DESIGN DS	DRAWN BY DS	DART AEROSPACE LTD HAWKESBURY, ONTARIO, CANADA	
CHECKED JM	APPROVED KE	DRAWING NO. DEO 9137	REV. A SHEET 1 OF 1
DATE 99.03.01		TITLE 206 SADDLE MACHINING CHANGE	SCALE NTS
A	99.03.01	NEW ISSUE (NC 006)

DART ENGINEERING ORDER

TO AMEND DWGS: D2662 REV. B
D2664 REV. B

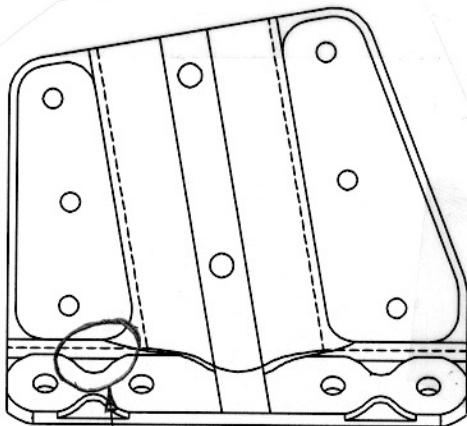
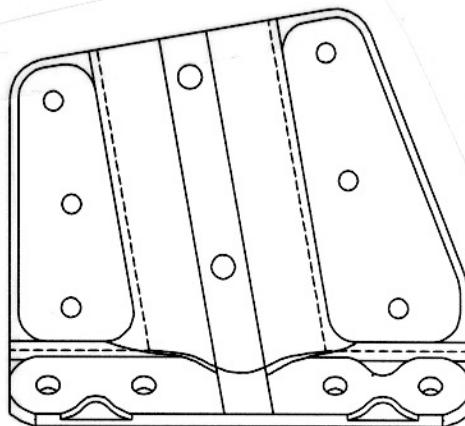
ON PARTS D2662-1/-2 AND D2664-1/-2, THE MACHINING OF THE PARTS
CAN BE MODIFIED AS FOLLOWS TO MAKE PROGRAMMING EASIER:

DO NOT REMOVE THIS
MATERIAL IN THIS AREA ONLY
